Access Compliance Report

Public Rights-of-Way

(Curb Ramps)

Intersection ID: 10018128	Main Street: LIGON_CT	Cross Street: N/A	Location:	N
ADA ID: E6BBBD6A8DE9	Ramp Type: Perp	Initial Pass/Fail: Fail	Overall Compliance: No	Severity Score: 22.5
Codes/Mitigation Info/Possible Solution		Field Measurements/Component Compliance

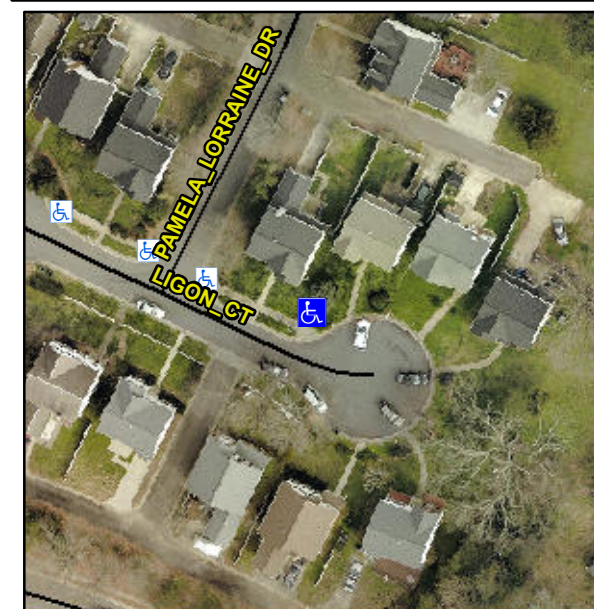
Not Found, R304.5.1, R304.2.2, R304.5.3

Compliance	Description	Data	Compliance	Description	Data
N/A	Ramp Length (in)	87.0	No	Ramp Slope (%)	9.7
No	Ramp Width (in)	45.0	No	Ramp XSlope (%)	2.5
N/A	Flare Type LT	N/A	N/A	Flare Type RT	N/A
N/A	Flare Slope LT (%)	N/A	N/A	Flare Slope RT (%)	N/A
N/A	Flare Traversable LT?	N/A	N/A	Flare Traversable RT?	N/A
N/A	Landing Length (in)	N/A	N/A	DWS Provided?	N/A
N/A	Landing Width (in)	N/A	N/A	DWS Contrast?	N/A
N/A	Landing Slope (%)	N/A	N/A	DWS Length (in)	N/A
N/A	Landing X Slope (%)	N/A	N/A	DWS Full Width?	N/A
N/A	Landing Curb? (Y/N)	N/A	N/A	DWS Offset (in)	N/A
N/A	Shared Landing?	N/A			
N/A	Gutter Ponding?	N/A	N/A	Gutter Slope (%)	N/A
N/A	Gutter Lip Ht (in)	N/A	N/A	Gutter X Slope (%)	N/A
N/A	Painted X Walk1?	No	N/A	Painted X Walk2?	N/A
	X Walk 1 Direction	To S		X Walk 2 Direction	N/A
N/A	X Walk 1 Width (in)	N/A	N/A	X Walk 2 Width (in)	N/A
	X Walk 1 Slope (%)	2.2		X Walk 2 Slope (%)	N/A
	X Walk 1 X Slope (%)	2.1		X Walk 2 X Slope (%)	N/A

Remove & Replace Entire Ramp.
